**UNECE draft brochure on persimmons**

**Alternative photos as requested by GE.1 at their 63rd session**

**Alternative photos as requested by  
GE.1 at their 63rd session,  
21 to 24 April 2015**

**Photo 45b**  
**Class I “slight skin defects”**  
**Rubbing affecting in total 1/16 of the**  
**surface of the fruit**  
**Limit allowed**

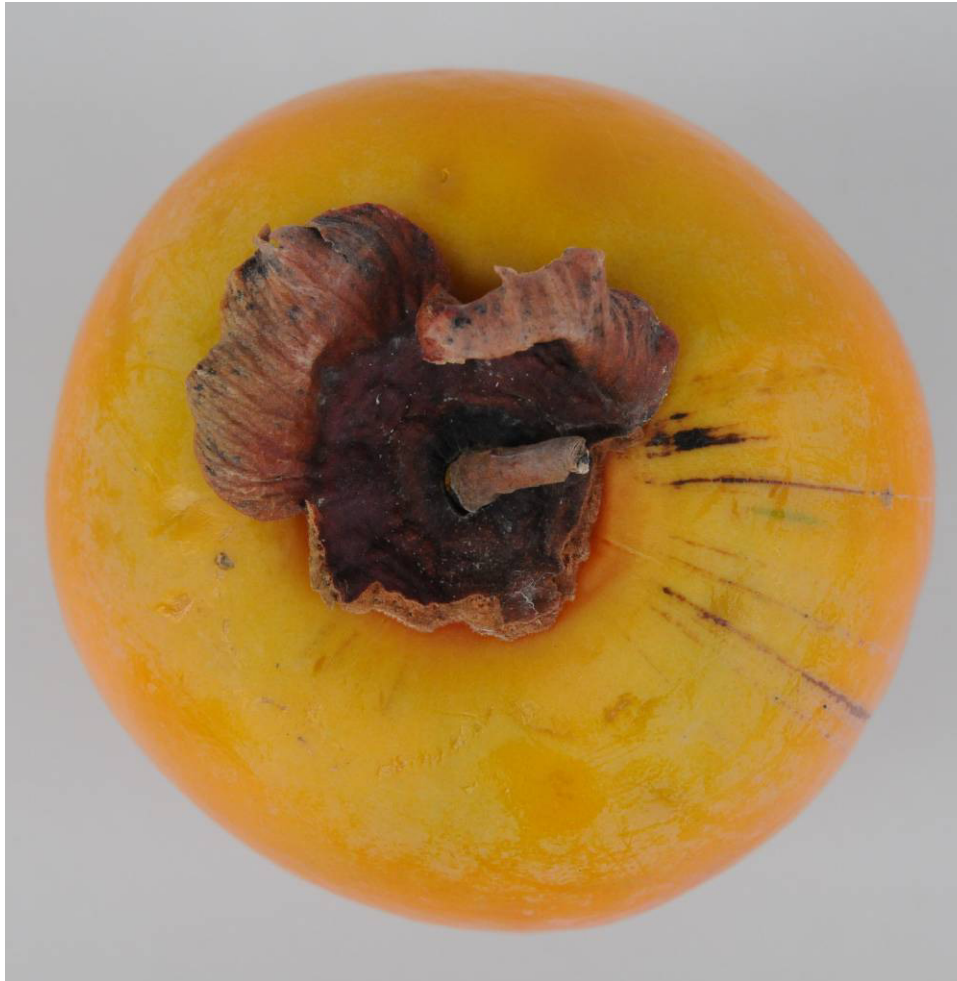
**delete cracks and make black  
area somewhat lighter in colour**

We did carefully check this photo. Even if the cracks would disappear by means of Photoshop the defect would look more Class II than Class I.  
The skin defect on the alternative photo is too large for Class I, eventually the UNECE publication department can help to shrink the area to make it 1/16 of the surface of the fruit.
